TERRY HARVARD - ETSO - DISTILLING
 Manville Corp. - 641 - 3331

July 29, 1988

Subject: Instrumentation Cable Tray Fireproofing

DL-2 Cable Tray
Asbestos Fire

Cable Tray With
Asbestos Fire Protection

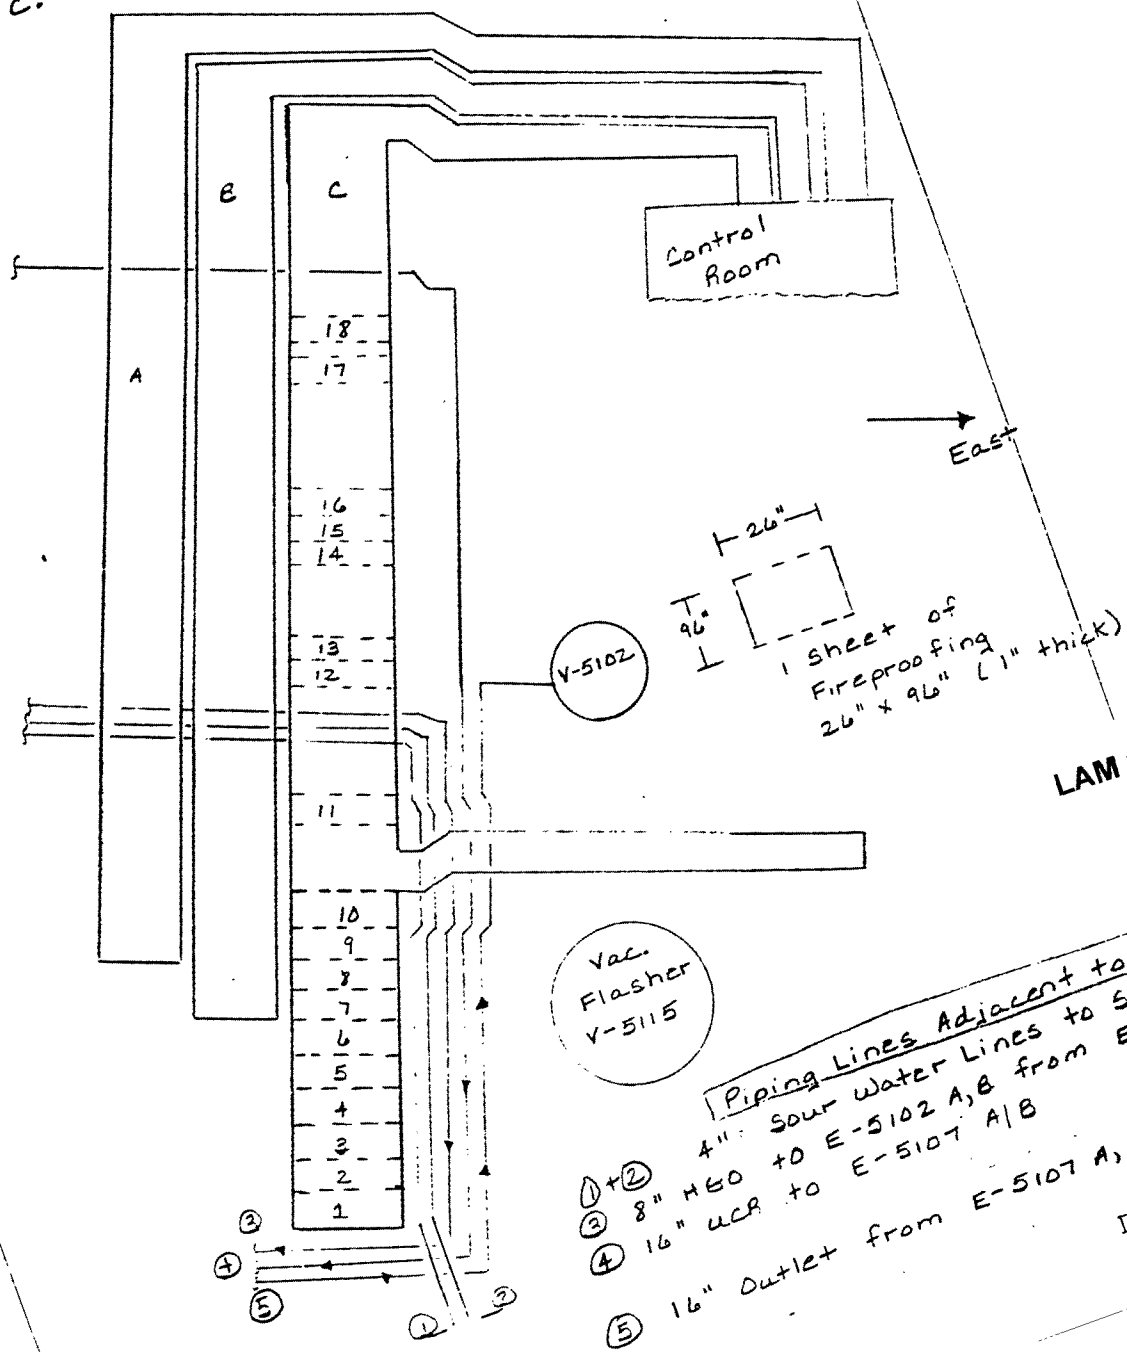
P1 I have reviewed the condition of the DU-2 cable tray which was fireproofed with insulation containing asbestos. Approximately 40% (300 sq. ft.) of the insulation has been damaged due to the cable tray being used as a walkway. To remove the damaged sheets of insulation (18 sheets 26in. x 96in.) would cost \$1,211 while the cost to replace the ^{damaged} insulation would be \$7M.

The instrument cable tray runs from the south end of the pump alley to the control room. Sheets of insulation that have been severely damaged are identified on the attached sketch.

PC Above the cable tray are overhead cooling fans which enhance the chances of the asbestos becoming airborne. Cable trays directly adjacent to the cable tray of concern ~~were found to have no fireproofing material (see sketch) on sides and the bottom.~~ Cable tray C has no insulation?

P5 Due to the condition of some fireproofing sheets, I feel ~~we~~ that the ~~should remove the damaged material~~ ^{should be removed}. If a decision is made to replace the damaged top fireproofing cover, I feel we should use the Marinite I insulating board which should be sealed with undercoating and painted with epon ester gray. Also, some type of support (angle iron) under the top layer should be added for additional strength. The Marinite for the sides and bottom of the cable tray need not be replaced but must be sealed.

Please Note: Cable Trays A+B currently contain no fireproofing. These trays are located next to Tray C.

DU-2 Cable Tray With Asbestos Fire Protection

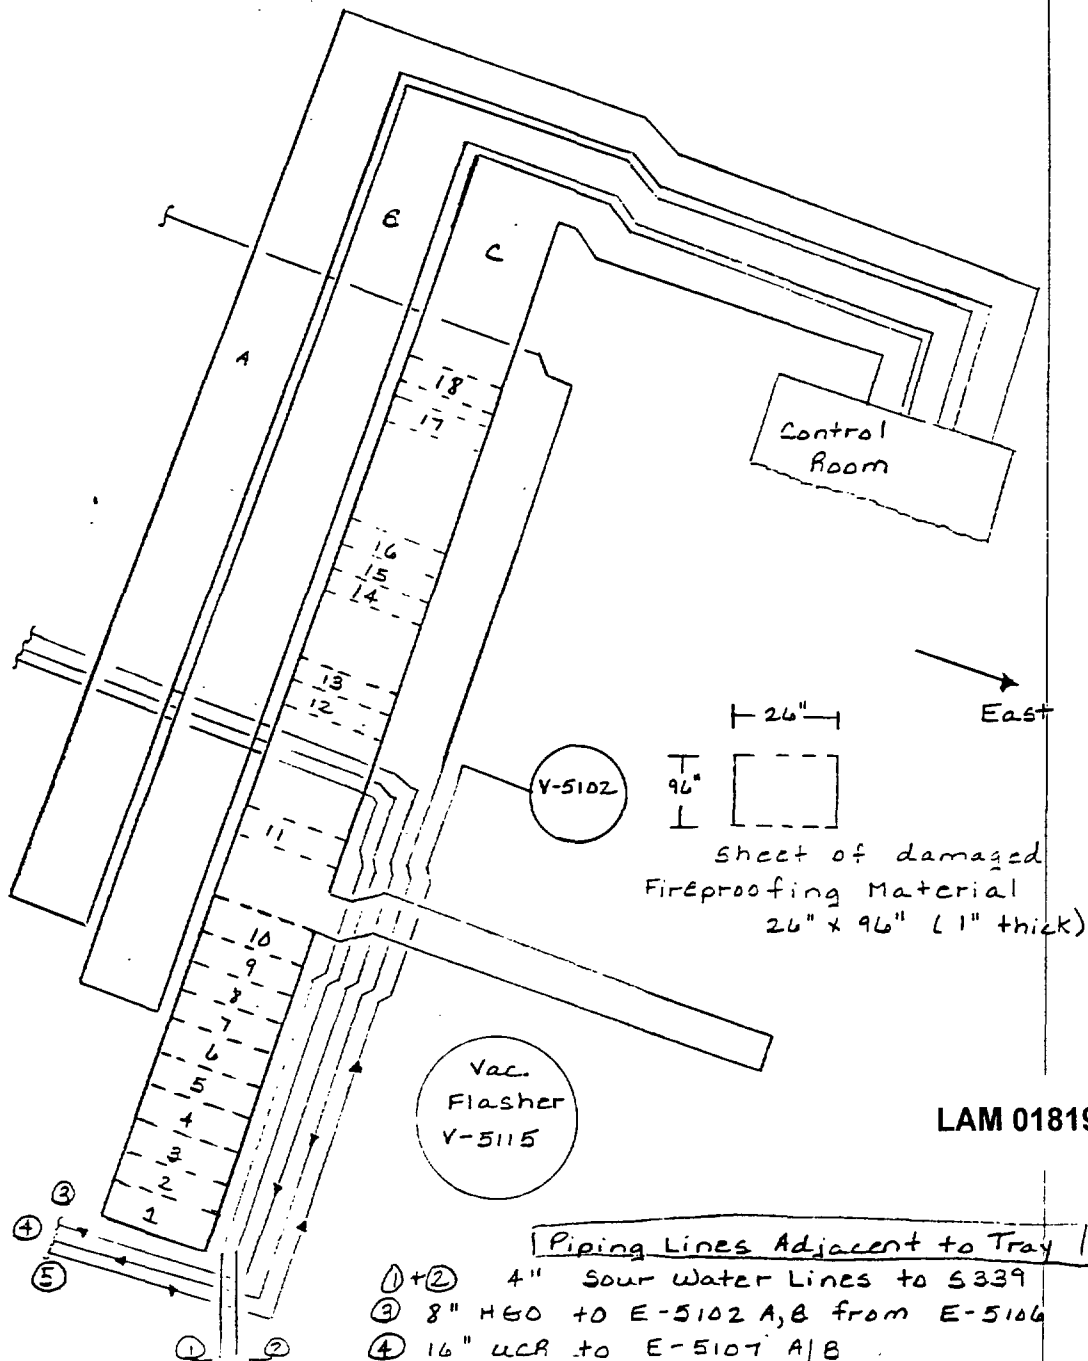
The instrument cable tray runs from the south end of the pump alley to the control room. Sheets of insulation that have been severely damaged are identified on the attached sketch.

Above the cable tray are overhead cooling fans which enhance the chances of the asbestos becoming airborne. Cable tray B directly adjacent to cable tray C (see sketch) contains fireproofing material on the sides and bottom but has no top cover. Cable tray A contains no fireproofing material.

Due to the condition of some fireproofing sheets, I feel that the damaged material should be removed. If a decision is made to replace the damaged top fireproofing cover, I feel that we should use the Marinite I insulating board which should be sealed with undercoating and painted with epon ester gray. Also, angle iron supports attached to the cable tray on two foot centers under the top layer of Marinite will give additional strength. The Marinite for the sides and bottom of the cable tray need not be replaced but must be sealed.

SKETCH
 04-2 Cable Tray With
 Asbestos Fire Protection

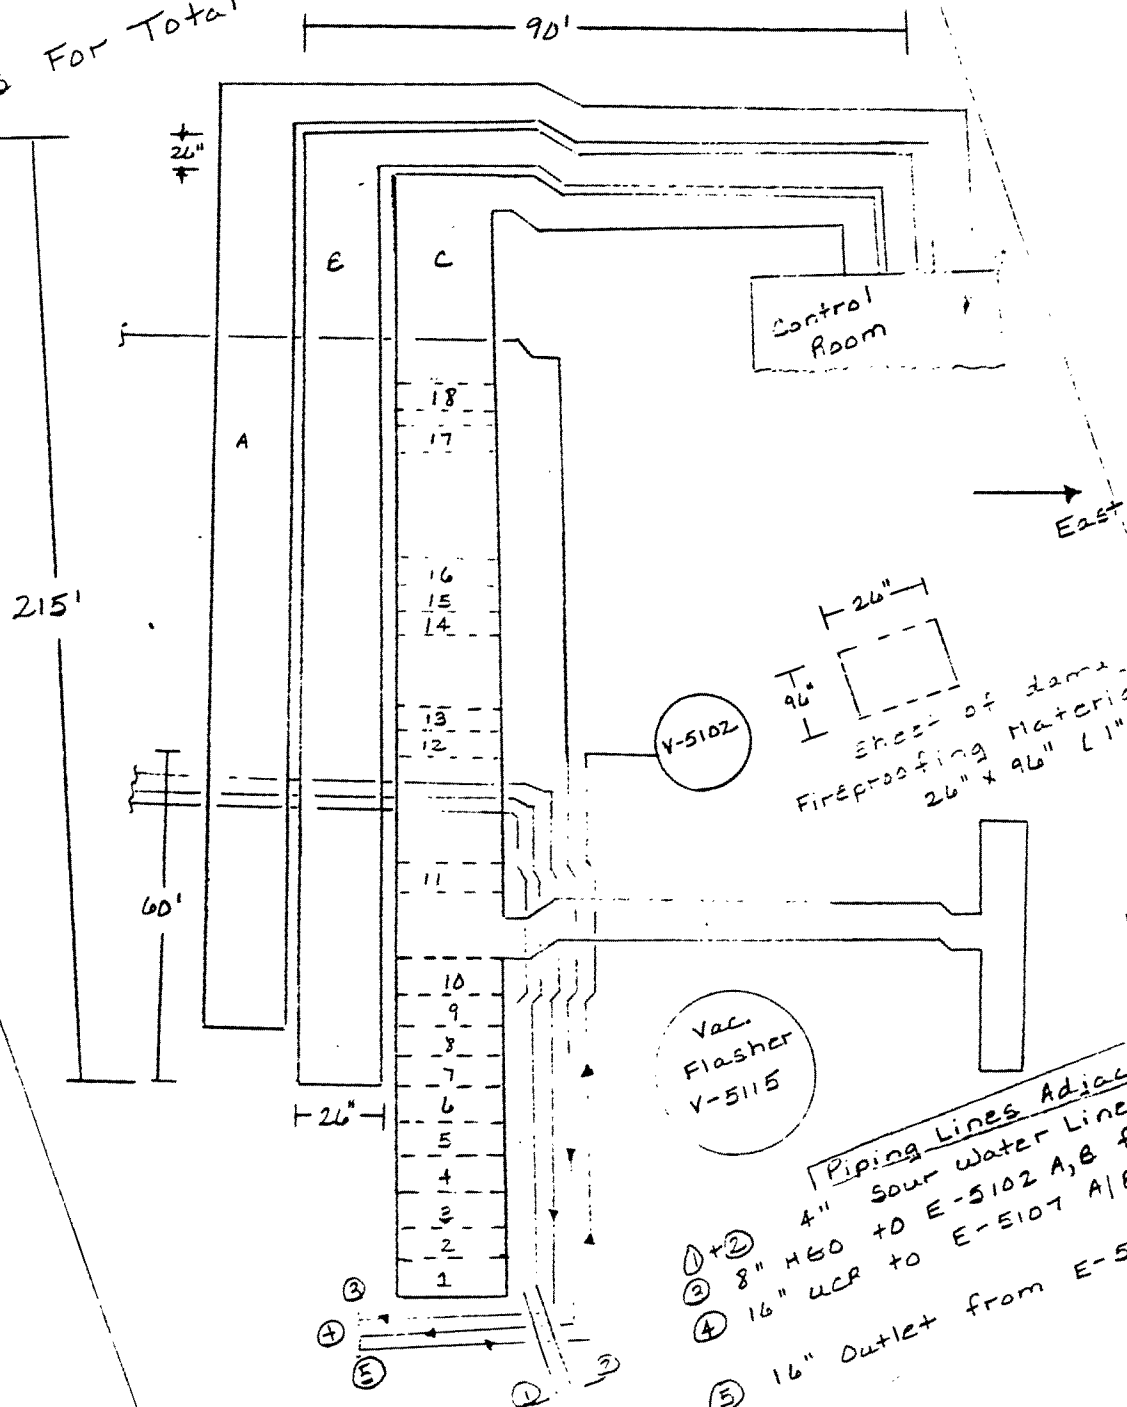
Dimensions: Cable Tray B
 For Total Removal & Installation
 of Trays C+B

ADD MHRS For Total Removal & Installation
 of Trays C+B
